Whitworth Street Planning Comparison

Since planning approval in 2016 the site has been purchased by Vision Manchester Limited. The client has engaged a full design team and RussellWBHO to update the detail design to the required regulations, agree a building contract and construct the development. Through this process a number of design changes are being proposed.

This updated document is being presented to Manchester City Council Planning Department to illustrate and explain the nature and extent of the proposed changes and to seek the Council's formal approval through the necessary planning process.

3.26 Proposed Elevation West

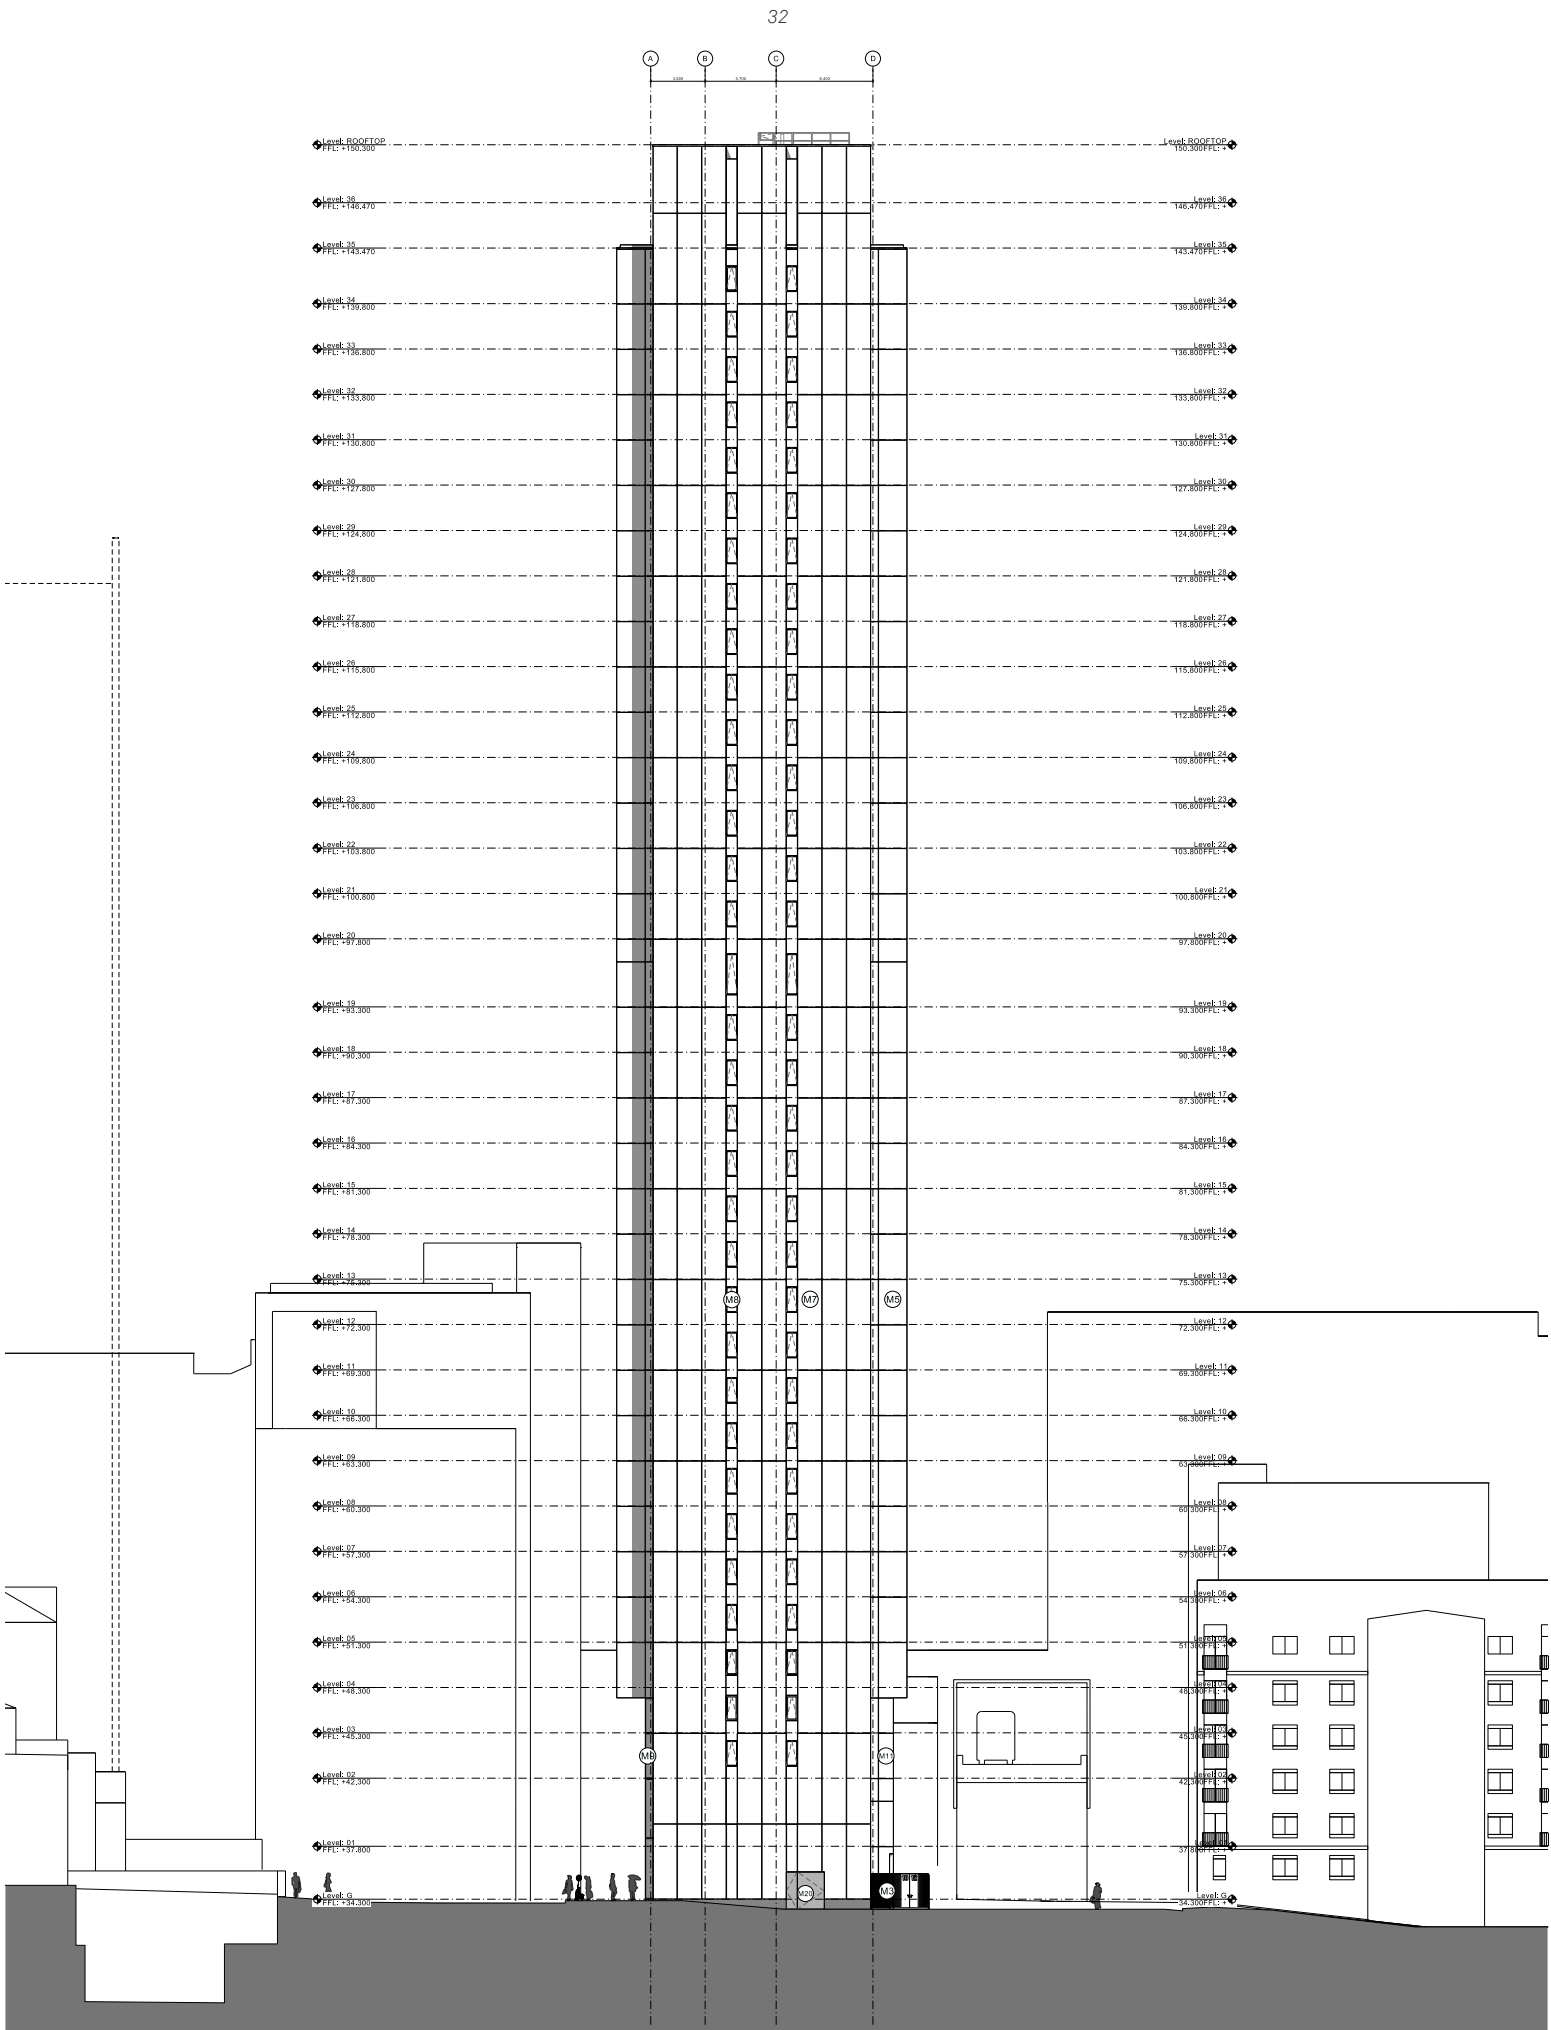
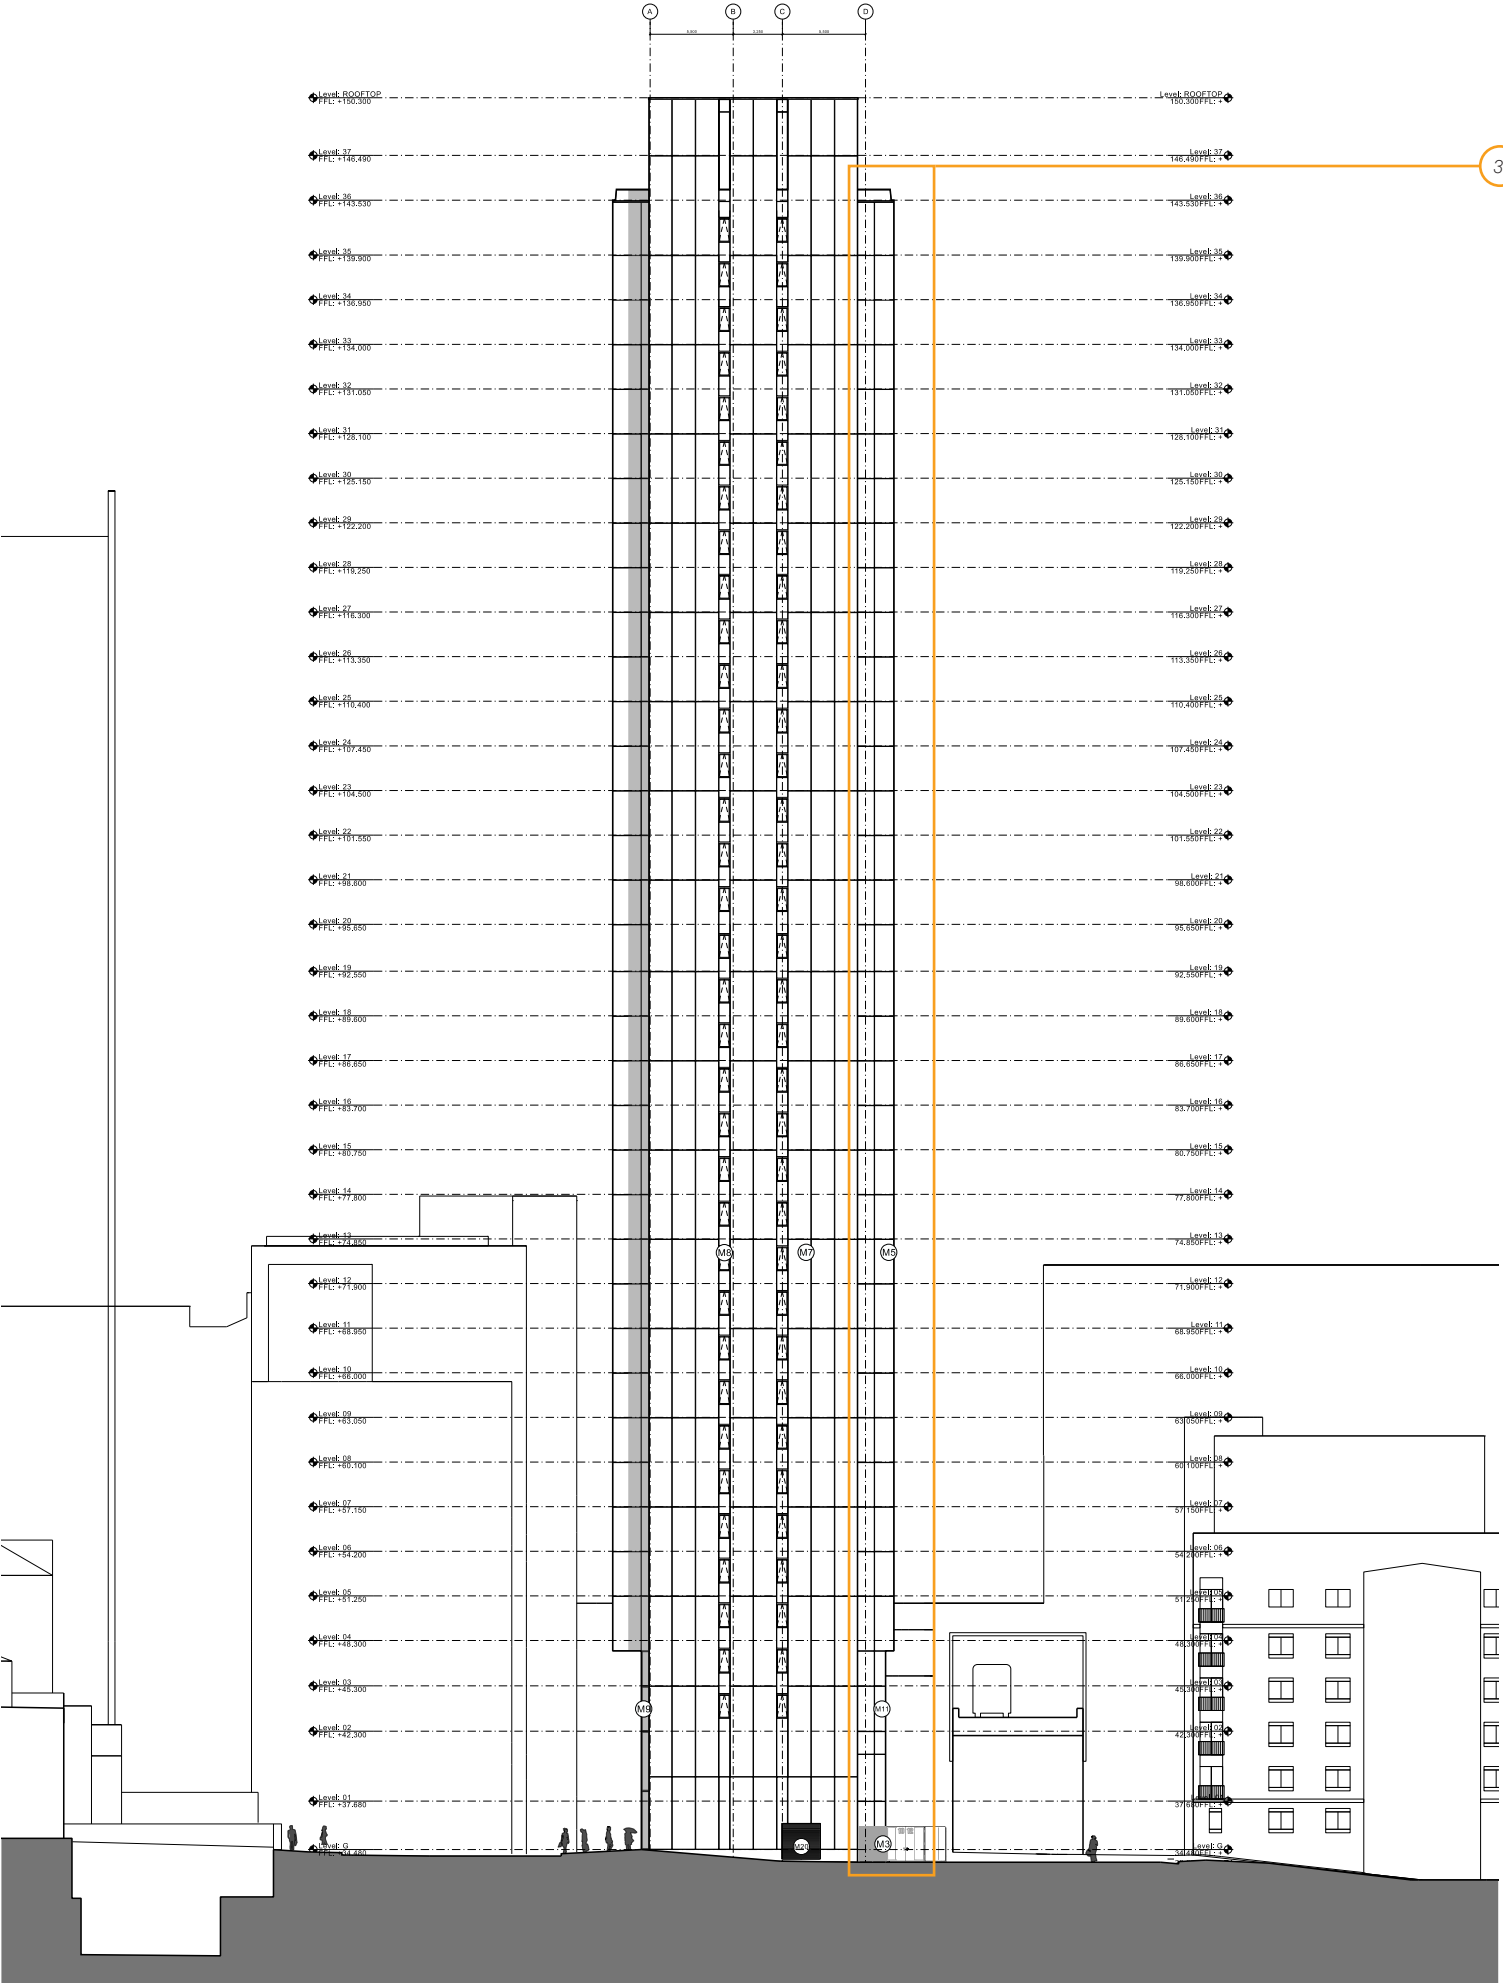
- 1a - Core Repositioned
- 1b - Main body of south facade to match north facade
- 1c - Entrance relocation
- 1d - Form of roof pavilion
- 1e - Apartment & amenity layouts
- 1f - Inclusion of commercial unit & dedicated entrance
- 2a - Reduced floor to floor heights
- 2b - Additional floor
- 2c - 2 no. Guest Beds & 2 no. 1 Bed become 2 no. 2 Bed & 2 no. 3 Bed
- 3 - South 'picture frame' reveal depth reduced by 600mm
